Block Island Wind Farm CVA

Status of Verification of Substructure
Installation (July 19 to August 24)

August 25, 2015

Installation of 3rd P1 Pile Jacket 3

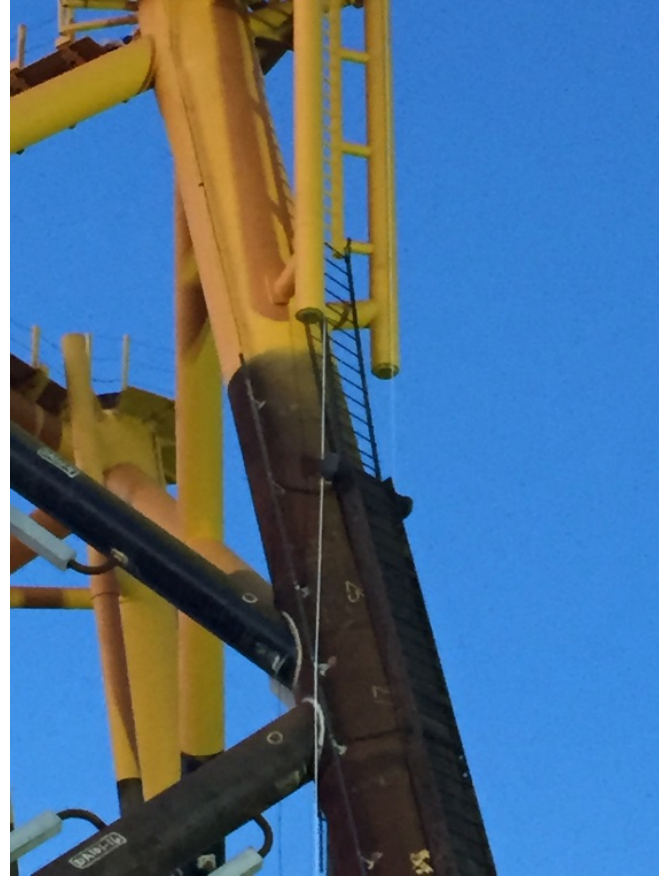
Status of BIWF - EHS
